PRODUCT UPDATE

Number: #067
 By: LEMO HQ / Dennis Warren
 Date: June 23, 2010

New Improved Mid-pieces for In-line 0B Receptacles

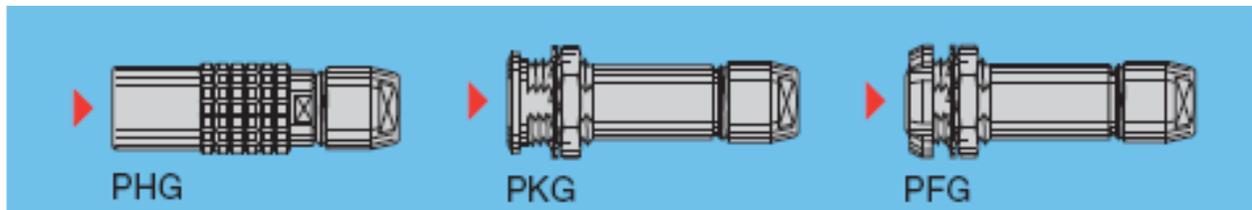
Size 0B receptacles now have an improved mid-piece and associated shells. The new mid-pieces will make the 0B in-line receptacles easier to assemble. The 2 mid-piece halves will capture the insert within the mid-pieces rather than that of the current design where the insert is at the end of the mid-pieces.

The following models will be affected, PH*.0B, PK*.0B and PF*.0B. (* = various option keyways)

OLD Mid-piece Part Numbers: (PHG.0B.150.LN + PHG.0B.151.LN = **PHG.0B.155.LNN**)

NEW Mid-piece Part Numbers: (FGG.0B.151.LNP + FGG.0B.150.LNP = **FGG.0B.155.LNNP**)

The new mid-pieces will only work with the new style shell. The internal construction for the new mid-piece is different.

The completed in-line receptacle is form, fit or function compatible with current and older mating plugs.
